**Design Exceptions
(Contract Document)**

**Innerbelt Bridge
Construction Contract Group 1 (CCG1)**

Subject: Cleveland Innerbelt Project
CUY – 71/90 – 16.79/14.90, PID: 77510
Design Exceptions CCG1

INFORMATION FOR EXCEPTION TO THE MINIMUM DESIGN STANDARDS

EXISTING CONDITIONS - SHOULDER WIDTH

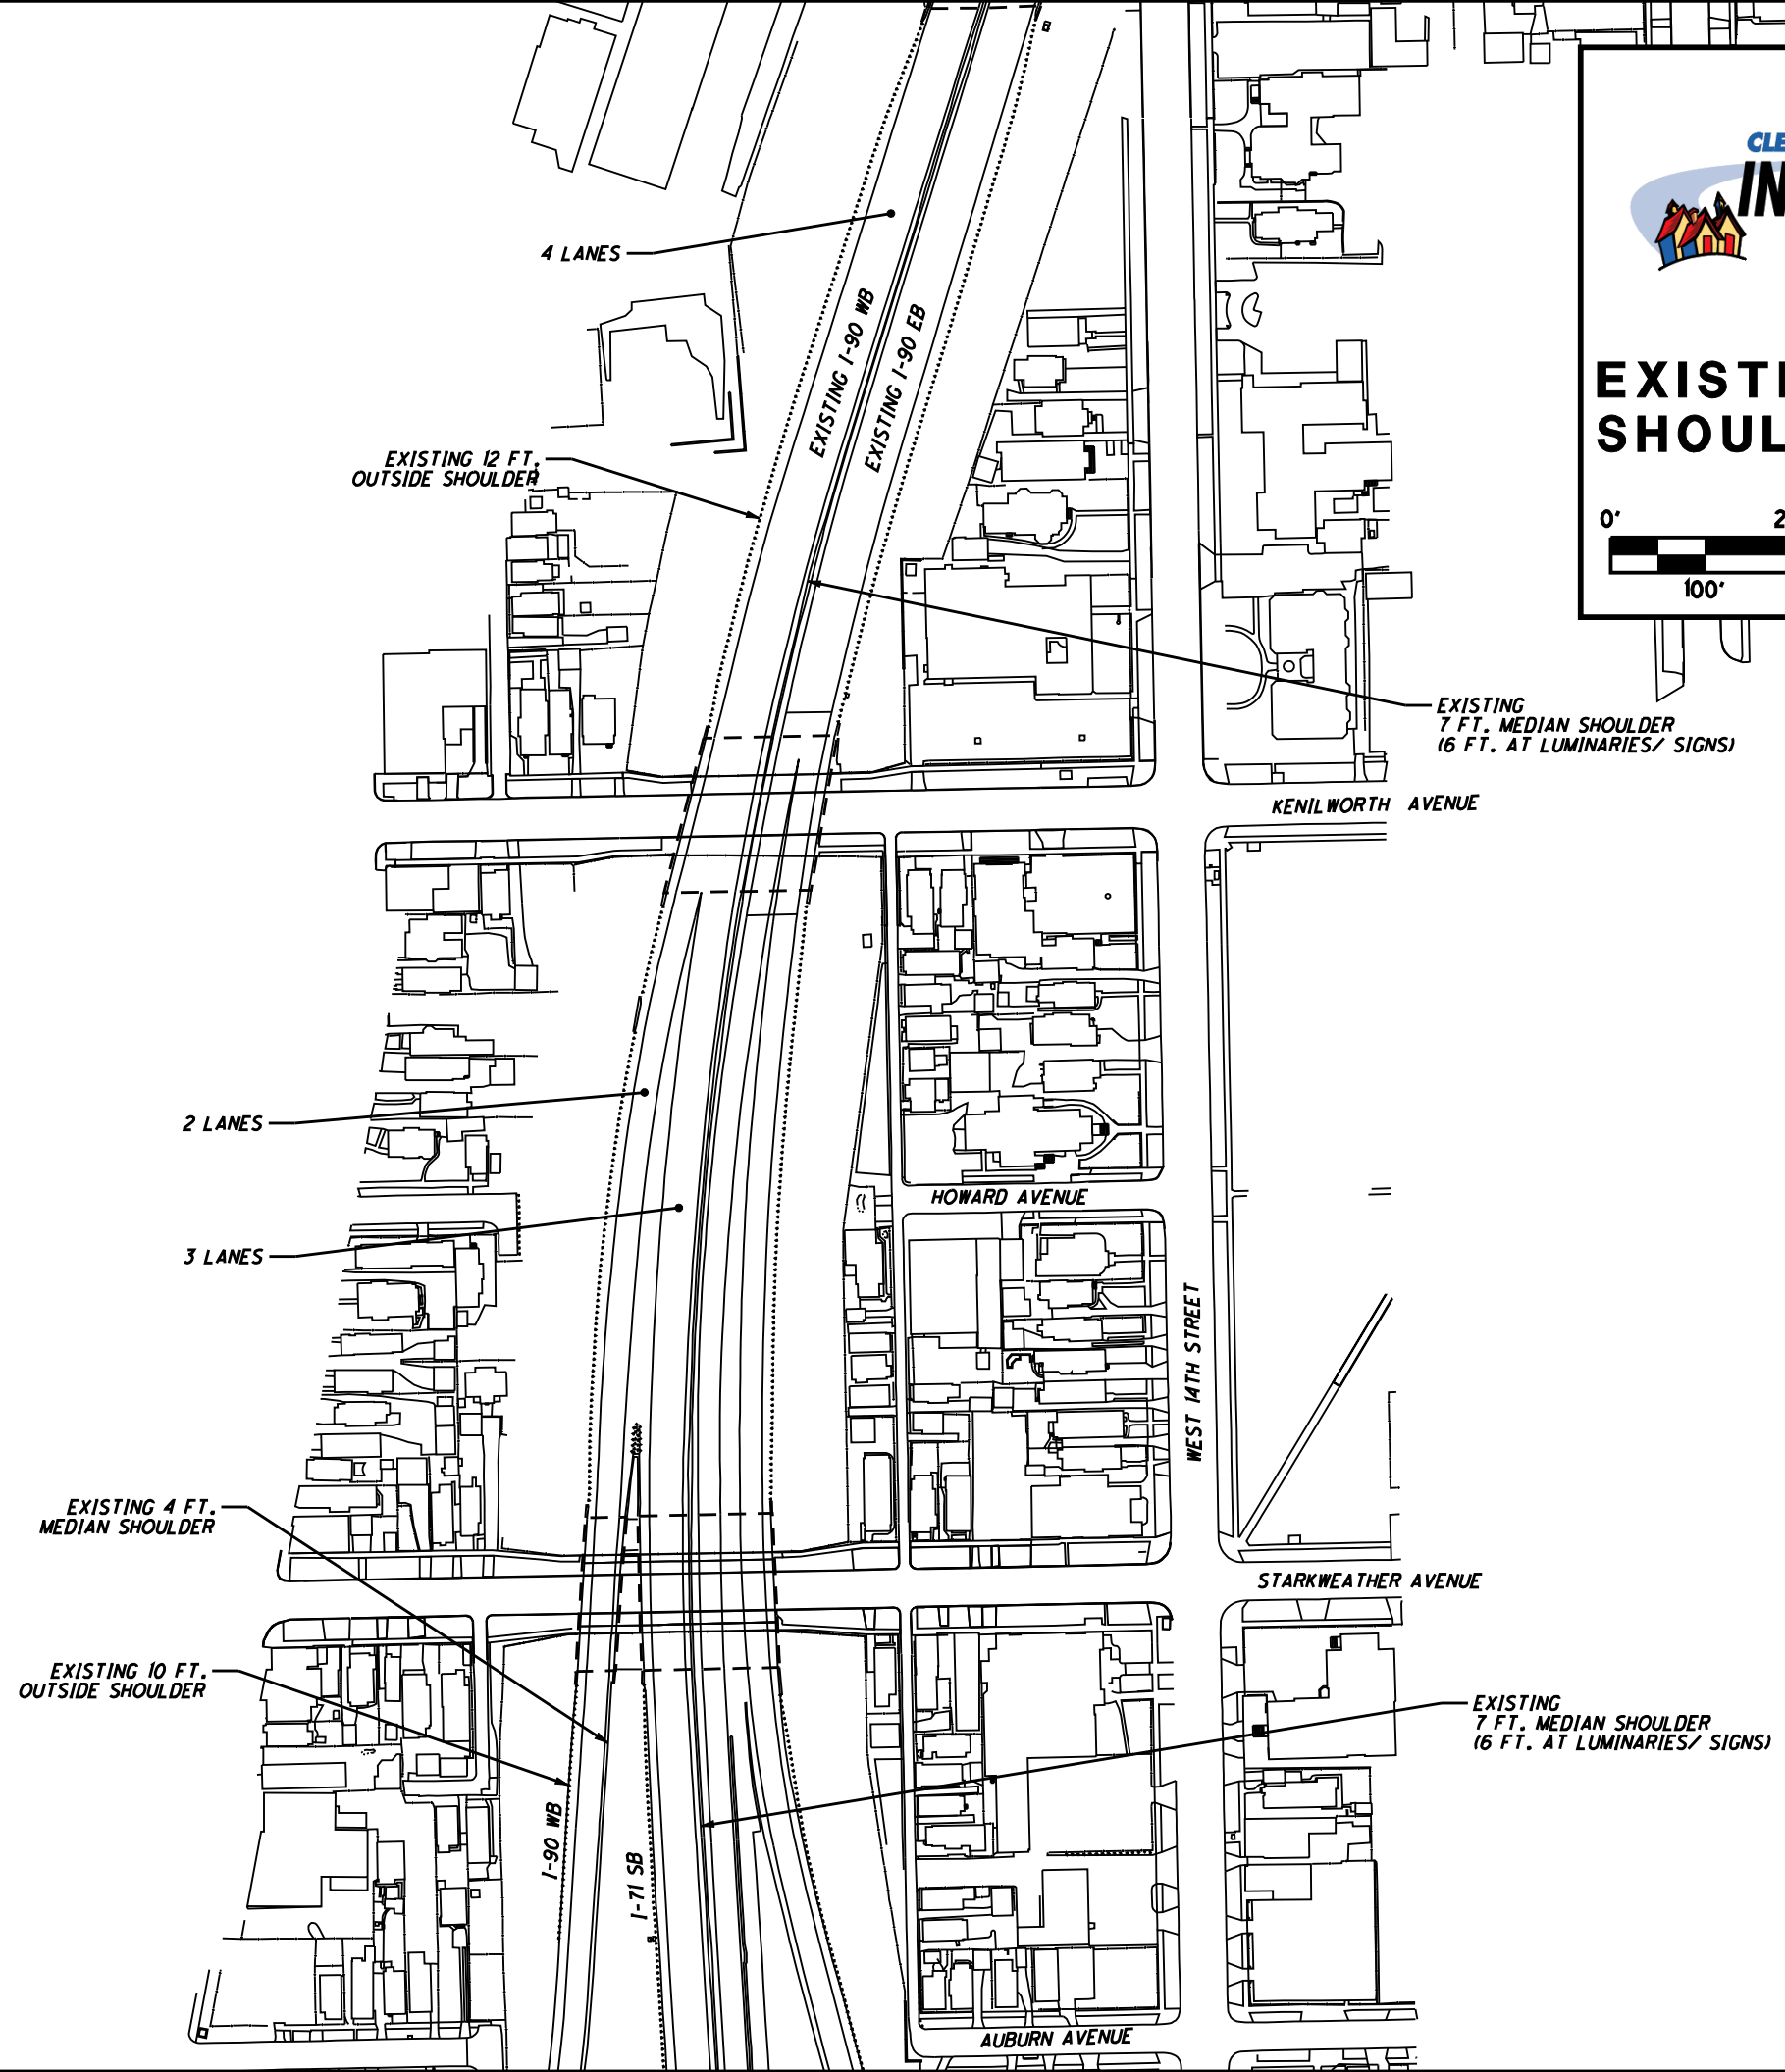
South of the Central Viaduct Bridge, the outside lane (number 4 lane) drops to WB I-90, the two inside lanes (number 1 and 2 lanes) continue onto SB I-71 and the number 3 lane is a decision lane (see Existing Conditions – Shoulder Width Figure). After transitioning from the shoulders provided on the Central Viaduct Bridge, but before the off-ramp to WB I-90, the existing outside shoulder increases to 12' and the median shoulder is 7' wide. However, the median shoulder narrows to 6' wide whenever luminary or sign supports cause the median barrier to bump out. After the diverge of the WB I-90 ramp, the right (outside) shoulder on this ramp is transitioned down to 10' and the left (inside) shoulder is 4'. In addition, after the diverge of the WB I-90 ramp, the outside shoulder of I-71 is 9' and the median shoulder continues as 7' wide, narrowing to 6' whenever luminary or sign supports cause the median barrier to bump out. The median shoulder is 7' or less in width southbound on I-71 from the WB I-90 diverge to past Fulton Road (which represents the extent of available project mapping).

CONTRACT GROUP 1 - SHOULDER WIDTH DESIGN EXCEPTION

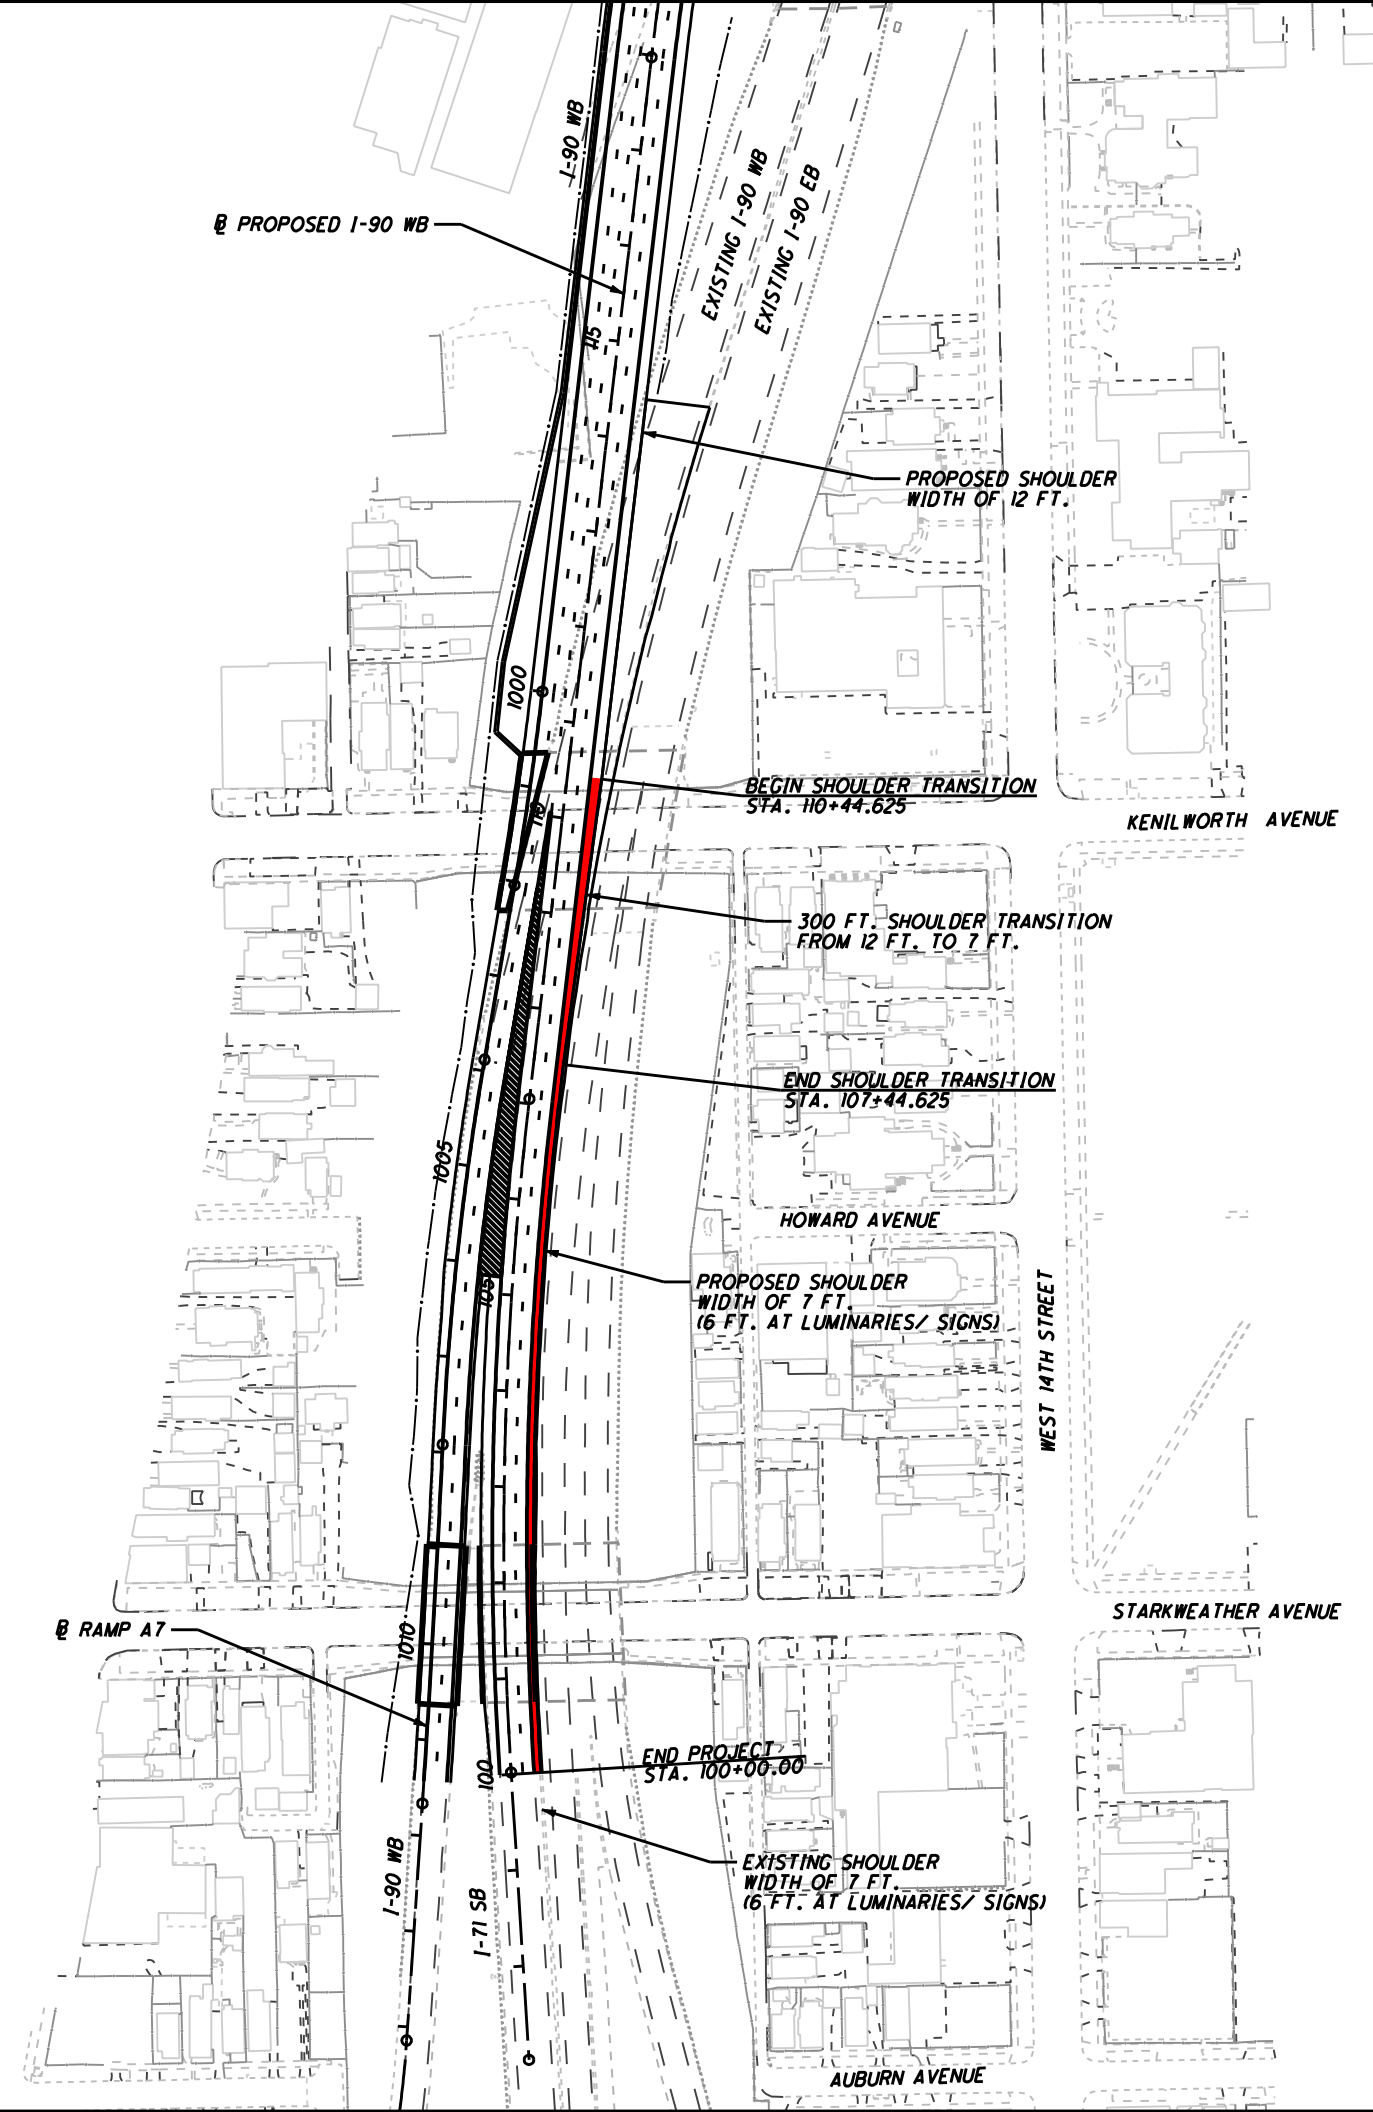
NOTE: AREAS OF DEFICIENT SHOULDER WIDTH SHOWN IN RED.

12' shoulder until Sta. 100+75.847. Then, the outside shoulder transitions from the proposed 12' shoulder to the existing 9' shoulder between Sta. 100+75.847 to Sta. 100+00. Past the gore, the median shoulder on I-71 begins to transition from the proposed 12' shoulder to the existing shoulder width of 7' (6' at locations where luminary or sign supports bump out the center median) over a distance of 300 feet from Sta. 107+44.625 to 110+44.625. Then, it maintains the existing median shoulder width for the last 744.625 ft. of the proposed work from Sta. 107+44.625 to 100+00.00. The median shoulders on southbound I-71 are substandard from Sta. 100+00.00 to 110+44.625.

The functional class of I-71 (Urban Interstate), and the fact that the projected truck traffic exceeds 250 DDHV, requires a minimum shoulder width of 12-feet on the median side of the roadway, per Figure 301-4, Note D, of the ODOT Location and Design Manual, Volume 1. The existing median shoulder width from Kenilworth Avenue to the southern terminus of the project is 7' (6' where luminary and sign supports bump out the median barrier). Over this same section, the proposed design utilizes a median shoulder width of 7' (6' where luminary and sign supports bump out the median barrier) in order to match into the existing shoulder width, as, based on the NEPA analysis, no major reconstruction of I-71 will be done.

EXISTING CONDITIONS - ONTARIO STREET ON-RAMP TO WB I-90

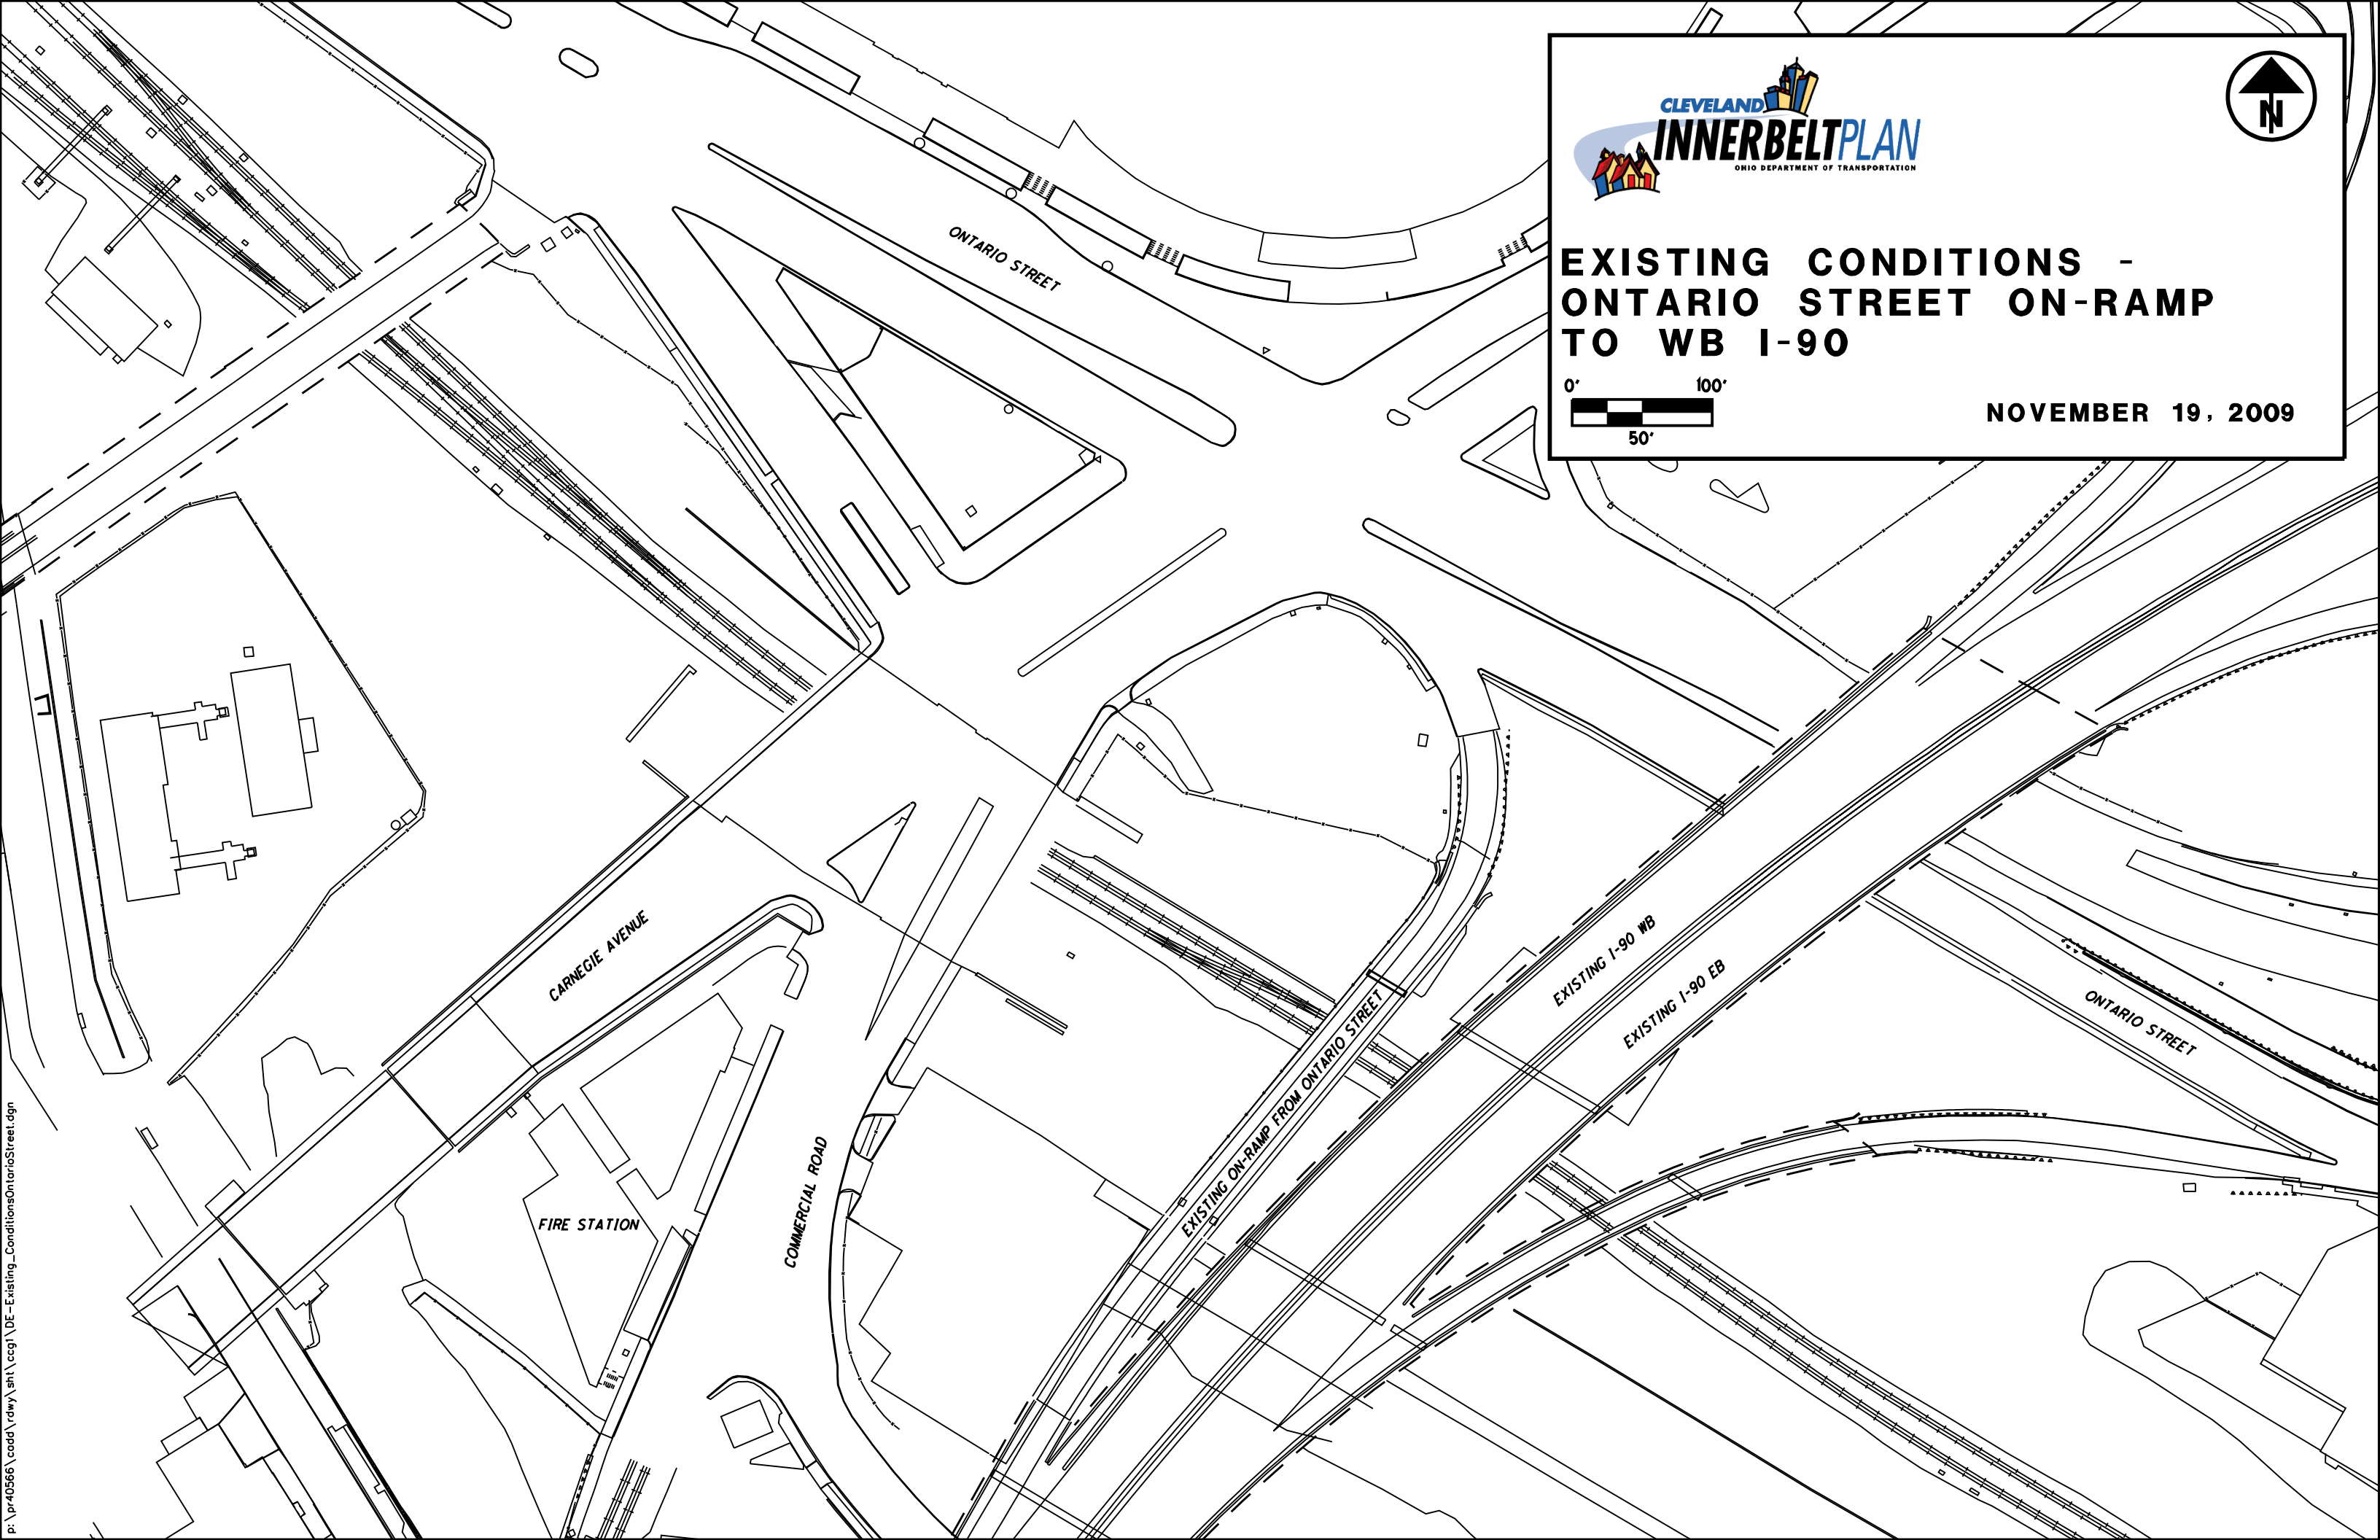
I-90 across the Central Viaduct Bridge has a current (2008) ADT of 119,000 vehicles per day with 6% truck traffic and a legal speed of 50 mph. The existing Ontario Street on-ramp to WB I-90 (see Existing Conditions – Ontario Street On-ramp to WB I-90) has an existing (2006) ADT of 5,836. Existing WB I-90 in the vicinity of the Ontario Street on-ramp carries three twelve foot lanes. The single lane Ontario Street on-ramp then enters as an add lane forming the fourth twelve foot lane across the Central Viaduct Bridge. The existing shoulders are deficient with inside shoulders that vary from 1'6" to 3'6" and outside shoulders that vary from 1'0" to 3'3".
